APPLICATION NO.	FILING DATE	FIRST NAMED INVENTOR	ATTORNEY DOCKET NO.	CONFIRMATION NO.
10/799,342	03/11/2004	David Charles Lyons	77012-325539	6247
58506 7590 06/27/2007 FAEGRE & BENSON, LLP PATENT DOCKETING 90 SOUTH SEVENTH STREET 2200 WELLS FARGO CENTER MINNEAPOLIS, MN 55402			EXAMINER PAINTER, BRANON C	
			ART UNIT 3609	PAPER NUMBER
			MAIL DATE 06/27/2007	DELIVERY MODE PAPER

Office Action Summary	Application No.	Applicant(s)	
	10/799,342	LYONS ET AL.	
	Examiner	Art Unit	
	Branon C. Painter	3609

DETAILED ACTION

Reproduced from G.B. Patent No. 852,169

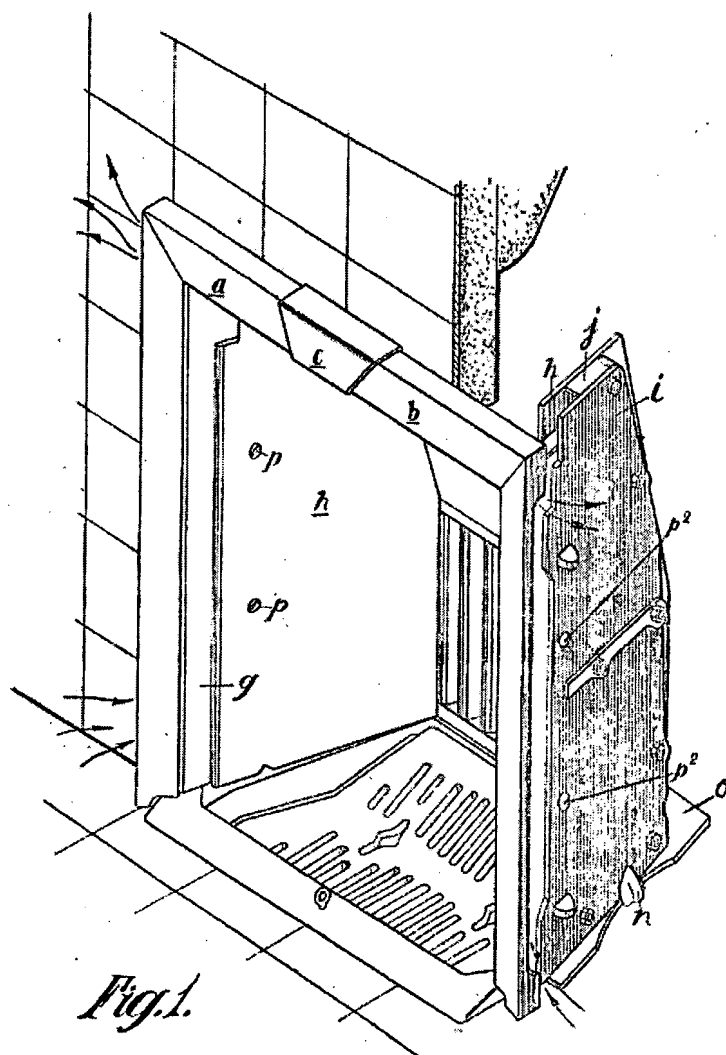
8. Claims 1-3, 9, 10, 13, 15-17, 24 and 25 are rejected under 35 U.S.C. 102(b) as being anticipated by Baxendale (G.B. Patent No. 852,169).
9. Regarding claim 1, Baxendale discloses a fireplace surround having all of the applicant's claimed structure, including:
 - a. "a first member having first and second ends..." (horizontal portion of "front member" a, Fig. 1).

- b. "...a second member having first and second ends, the first and second members being oriented generally horizontally with the first ends facing each other..." (horizontal portion of "front member" b, Fig. 1).
- c. "...a distance between the second ends of the first and second members defining a width of the surround..." (Fig. 1).
- d. "...wherein the first and second members are movable relative to each other to vary the width of the surround." ("two front members...interconnected at a midpoint in the width of the top of the fireplace by means which permit of adjustment of the width of such frame to suit the width of the fire opening," page 1, lines 19-24).

10. Regarding claim 2, Baxendale discloses a first overlap member configured to cover a spacing between the first ends of the first and second members ("member" c, Fig. 1).
11. Regarding claim 3, Baxendale discloses maximum spacing between the first ends of the first and second members no greater than the width of the overlap member (Fig. 1).

Reproduced from G.B. Patent No. 852,169

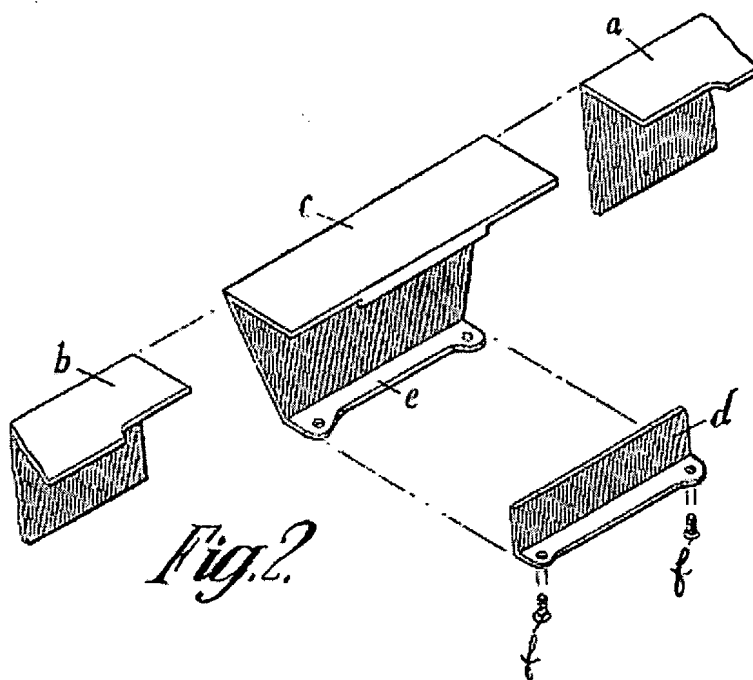
13. Regarding claim 10, Baxendale discloses a first overlap member with a front decorative surface and a rear surface including a track structure ("member" c, Fig. 2).

Reproduced from G.B. Patent No. 279,987 (Amended by examiner to highlight details)

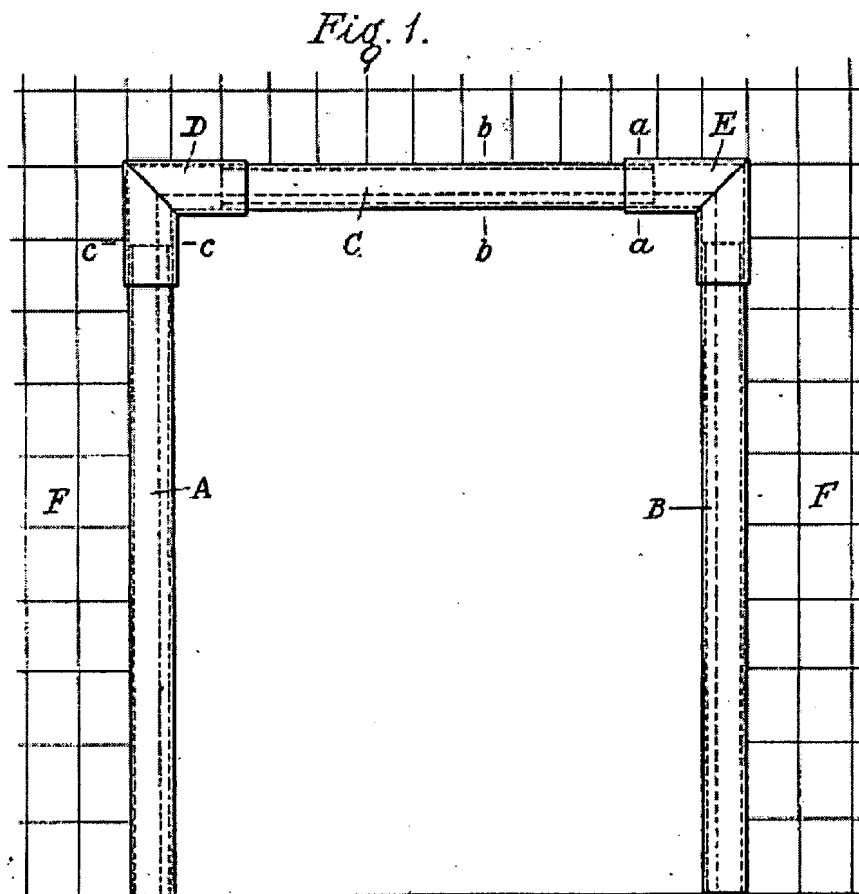
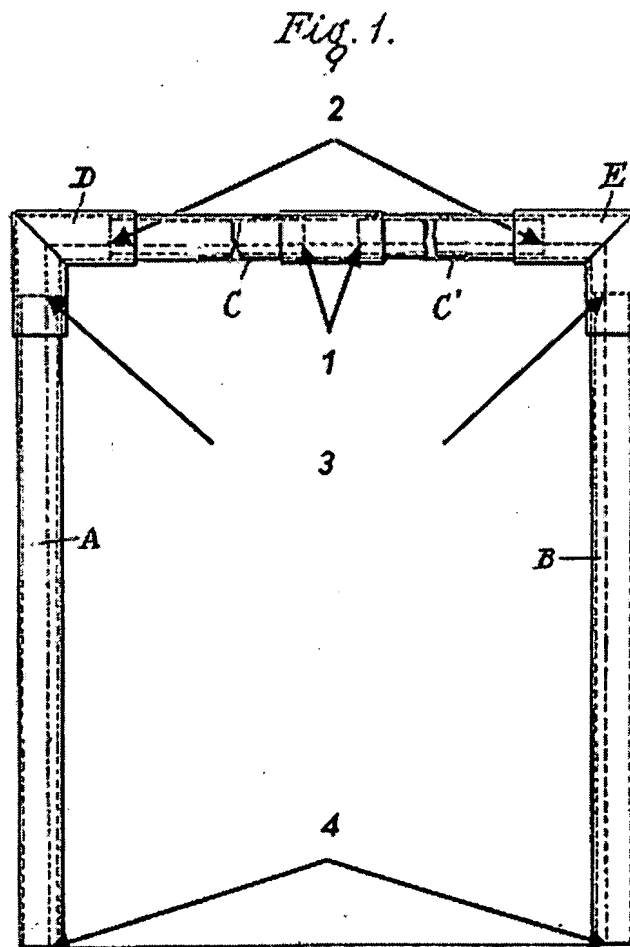
- a. "a first member having first and second ends..." ("metal length" C, amended Fig. 1). The examiner has amended Fig. 1, incorporating the plurality of pieces shown in Fig. 5 (referred to as "amended Fig. 1").

- b. "...a second member having first and second ends, the first and second members being oriented generally horizontally with the first ends facing each other..." ("metal length" C', Fig. 5, amended Fig. 1). Pollock states "I may make the lengths A, B, C in several pieces for each side or the top and join them together by fitting the meeting ends in covering pieces of thin metal which grip and conceal the joint in such a way that the lengths may be moved towards or away from each other in the covering pieces and so further enlarge or reduce the size of the frame, as will be understood from Figure 5" (page 2, lines 62-71).

- c. "...a distance between the second ends of the first and second members defining a width of the surround..." (Fig. 1, amended Fig. 1).
- d. "...wherein the first and second members are movable relative to each other to vary the width of the surround." ("metal lengths A, B, C and corner pieces D, E being so shaped or constructed that the ends of the lengths A, B, C can slide into the corner pieces D, E, the corner pieces D, E being of sufficient length to allow of the lengths A, B, C to be moved in the corner pieces D, E to suit the size of the surround F," page 2, lines 30-38).

21. Regarding claim 4, Pollock discloses first and second side members extending generally vertically from the second ends of respective first and second horizontal members ("metal lengths" A and B, Fig. 1).
22. Regarding claim 5, Pollock discloses first and second side members each including first and second ends of a length, the second ends of the first and second side members being coupled to the second end of respective first and second members, the length of the first and second side members defining a portion of a height in the surround (second ends 2 and 3, amended Fig. 1). The examiner notes that no

Reproduced from U.S. Pub. No. 2003/0140570

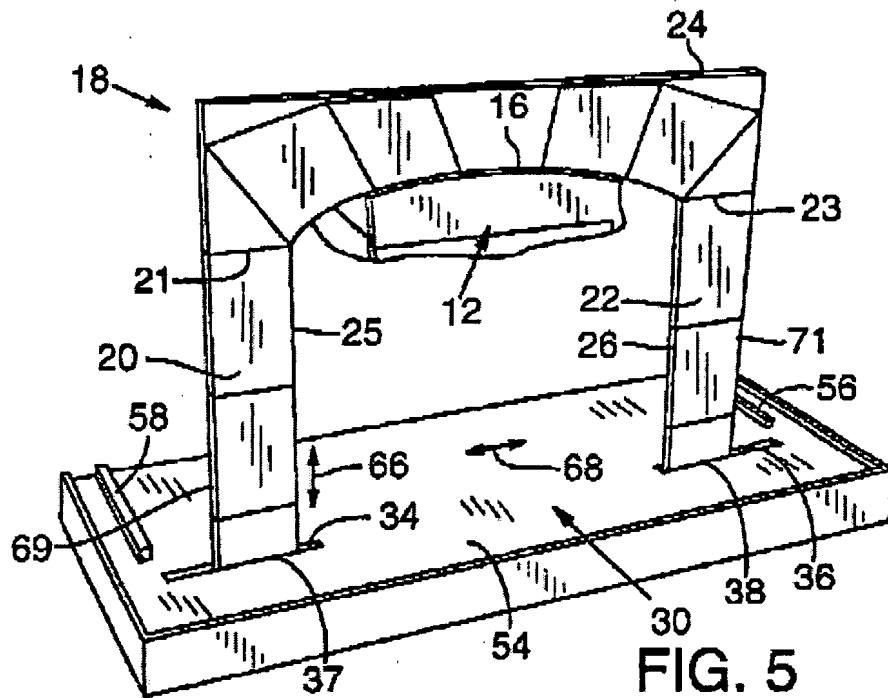
- a. "first and second side members extending generally vertically on opposing sides of a combustion chamber enclosure or fireplace..." ("surround leg portions" 20 and 22, Fig. 5).

- b. "...first and second overlap members configured to be coupled to respective first and second side members..." ("base" 30, Fig. 5). Richmond et al. states "the base may be of a plural piece construction" (paragraph 11, line 2). In this case, the base viewed from the front (as in Fig. 5) could have a left and

- right portion, with each portion corresponding to a side member, and fully containing the slot for engaging the corresponding side member.
- c. "...wherein relative movement between the first and second side members are respective first and second overlap member adjusts a height of the surround." ("movement upwardly and downwardly" 66, Fig. 5).

34. Regarding claim 19, Richmond et al. discloses first and second side members with first ends oriented generally downward facing ("lower end portions" 37 and 38, Fig. 5), and the first and second overlap members are configured to be coupled to the first end of respective first and second side members ("slots" 34 and 36 receiving first ends "lower end portions" 37 and 38, Fig. 5).

FIG. 1

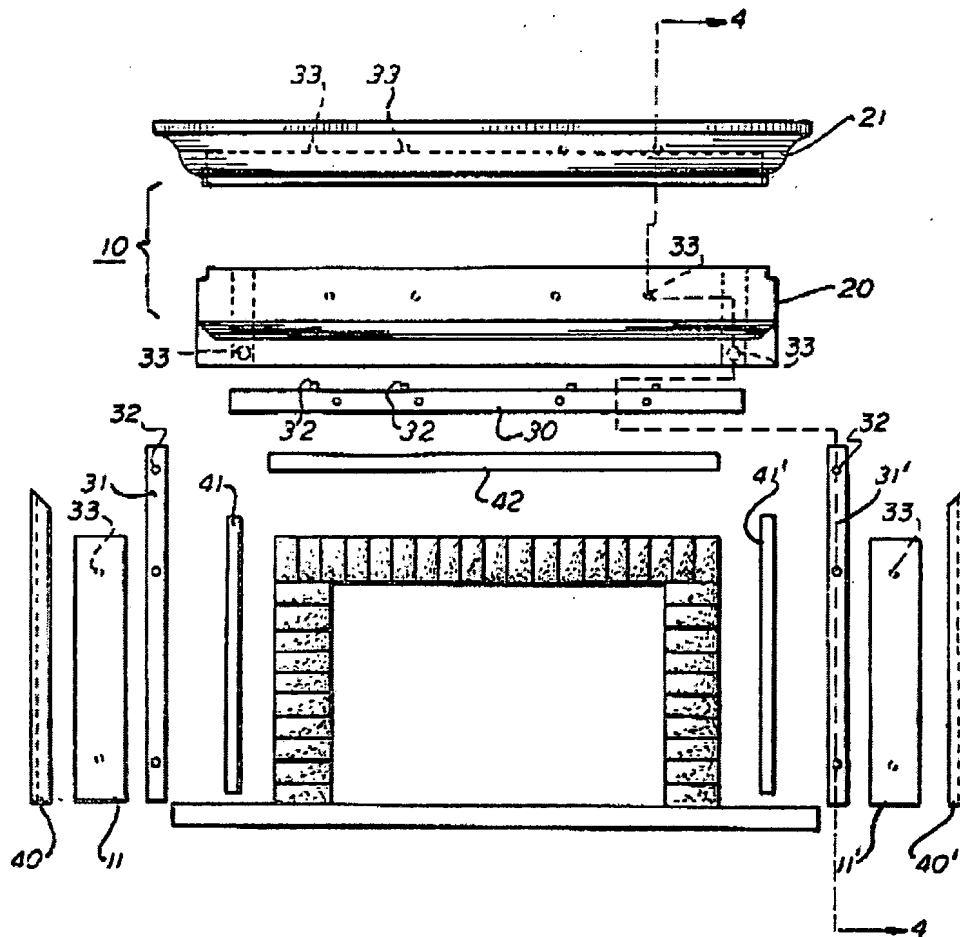
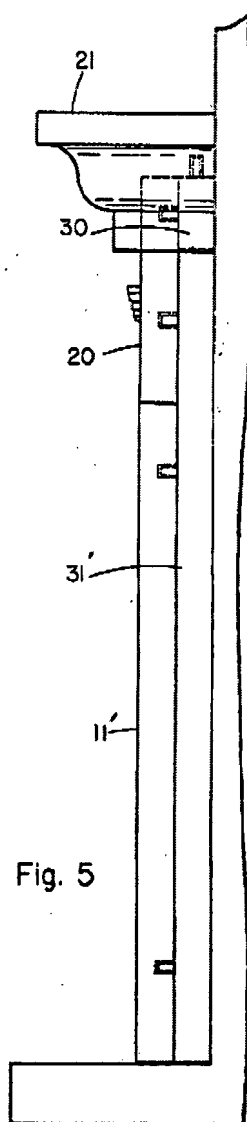
- c. Wright, et al. discloses a retaining bracket for mounting the surround to an exterior portion of the surrounding wall ("top support" 30, Fig. 1; "The assembleable mantelpiece may be installed ... by securing the top support 30 ... to the wall thereabout," column 2, lines 57-61) wherein the bracket supports the first and second members in fixed relation to one another ("male members" 32 on "top support" 30 supporting "face" 20, Fig. 1) [claim 7]; and separate retaining members for separately supporting the first and second members ("male members" 32, Fig. 1) [claim 8]. Mounting a retaining bracket as taught by Wright et al. ensures the first and second members of the surround are firmly secured in place.

- b. Pollock does not expressly disclose a mantle shelf for mounting on top of the top member.
- c. Wright et al. discloses a mantel shelf for mounting on top of the top member ("top" 21 for mounting on "face" 20, Fig. 1 and Fig. 5). Mounting a mantel shelf on top of the top member as taught by Wright et al. provides the fireplace surround owner with a traditional mantel, giving the owner additional surface area for displaying Christmas cards, candle assortments, and other decorative frippery.
